224HD Full Mortise Aluminum Geared Continuous Hinge

SUBMITTAL IDENTIFICATION SHEET

WEBSTER UNIVERSITY ISB
PROJECT NAME

Submittal Review
Specification Section: 087100 Door Hardware

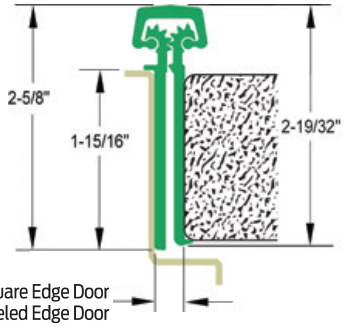
Confirm EPT cutout should be at 23 7/8"
